BYRON SHIRE FLOODPLAIN RISK MANAGEMENT COMMITTEE MEETING

Venue	Conference Room, Station Street, Mullumbimby
Date	Tuesday, 24 March 2020
Time	2.00pm

Report No. 4.2 **Draft North Byron Floodplain Risk Management Study and Plan**
Directorate: Infrastructure Services
Report Author: James Flockton, Drain and Flood Engineer
File No: I2020/418

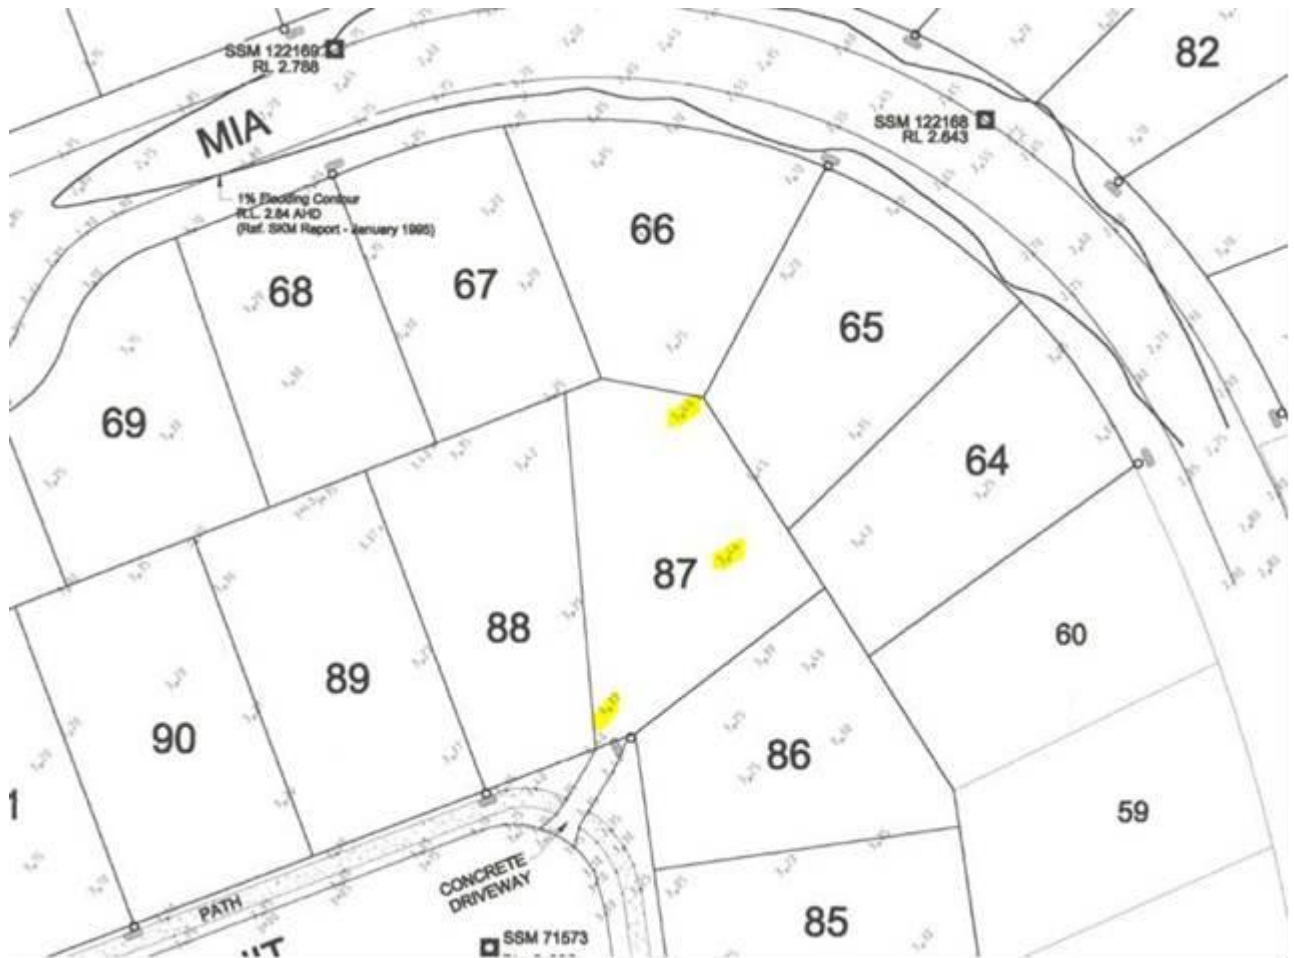
Attached are photos of notices on the site and of a block-wall built for the purpose of taking fill at South Golden Beach, within a no-fill zone declared under the Marshalls Creek Floodplain Management Plan.

My view is that Council and the state have invested deeply and behaved cordially to come up with Plans (like the one being developed right now) for sharing the joys and burdens of occupying floodplains. What is happening at 1 Kallaroo Circuit seems to break all those rules. If this is accepted, why would anyone conform to a Floodplain Management Plan.

My question is how did this happen?

5 *The development you have requested information about was approved by Council but the construction certificate and construction is being managed by a private certifier. Conditions of consent required the floor levels to be raised to the currently adopted 2050 Flood Planning Level to comply with Council's minimum floor level requirements. This is higher than the surrounding developments due to changes in flood planning heights, following revised flood studies and plans that considered more recent flood events and Council's climate change parameters, since adoption of the 1997 Marshalls Creek Floodplain Management Plan.*

10 *The land was originally filled to above the 1 in 100 year flood level in the early 2000s (WAE plans are dated 30/1/2002) as part of the "Fern Beach Estate" subdivision, which was approved by the Land and Environment Court in 1997.*

20 *The Tweed Byron Coastal Creeks Flood Study, Byron Shire Council Climate Change Assessment (March 2010) indicates a 2050 flood level in the vicinity of the site of 3.3m AHD (figure 3-2) and does not identify the site as being in a flood hazard area (figure 3-4). It is also noted that the land is not identified as being in a flood hazard area in figure 106 of the recently exhibited draft North Byron Flood Plain Management Study.*

25 *Accordingly, the development is consistent with the flood planning matrix in Chapter C2 of Council's DCP 2014, which does not prohibit filling in the "No Hazard" flood hazard areas.*

30 *Further the above court ruling effectively removed the no fill area over this area of land. Therefore Council does not have an avenue to successfully stop filling in this area.*
